RESPONSE TO REQUEST FOR ADDITIONAL INFORMATION

APR1400 Design Certification

RAI No.: 395-8478

Question No. 15.06.01-2

Figure 1 POSRV Schematic Diagram

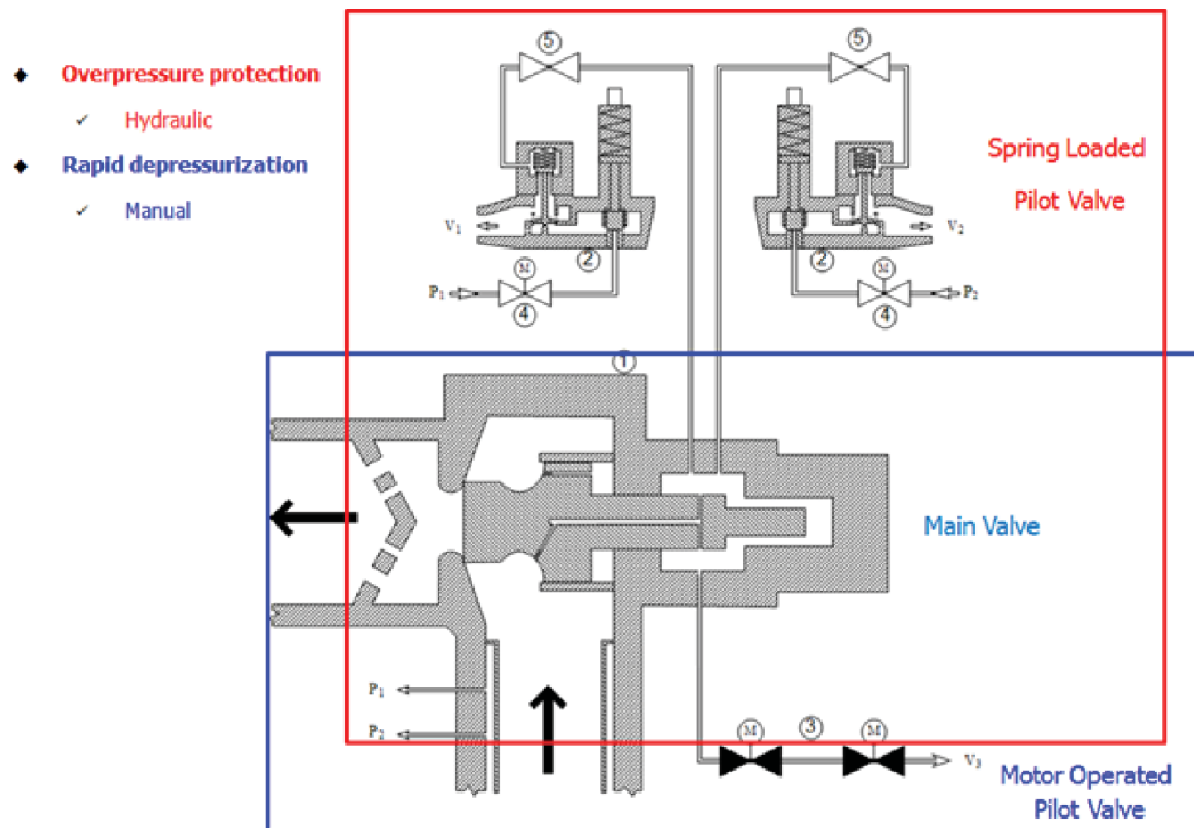
design.” NRC staff understands that the overpressure protection function of the pilot operated safety relief valves (POSRVs) is fully automatic and passive. NRC staff’s concern is in regard to the double motor operated pilot valves which can be manually operated from the control room. The RAI response does not address the potential for a spurious electrical signal or operator error, in regards to the operation of the double motor operated pilot valves, which would lead to an IOPRV event.

NRC staff requests that KHNP update Section 15.6.1 of the DCD with justification for stating that a spurious electrical signal or operator error is not applicable to the APR1400. If sufficient justification is not available, Section 15.6.1 of the DCD will need to be updated with an appropriate analysis to demonstrate compliance with the Commission’s regulations that underlie SRP Section 15.6.1. Additionally, Table 1.9-2 of the DCD needs to be updated accordingly.

3. The POSRVs perform both the overpressure protection function and the rapid depressurization function. The spring loaded pilot valve and the main valve in the POSRV perform the overpressure protection function using the passive hydraulic mechanism. Whereas, the motor operated pilot valves and the main valve in the POSRV perform the rapid depressurization function using the manual operation during the feed and bleed operation in a total loss of feedwater event. A schematic diagram of the POSRV is shown in Figure 1.

To prevent POSRVs from opening due to a spurious electrical signal or operator error, one of the two motor operated pilot valves is designed to be powered off during the normal operation as is described in DCD TIER 2, Chapter 16 Tech. Spec., Section 3.4.10 Pressurizer Pilot Operated Safety Relief Valves (POSRVs), SR 3.4.10.2.
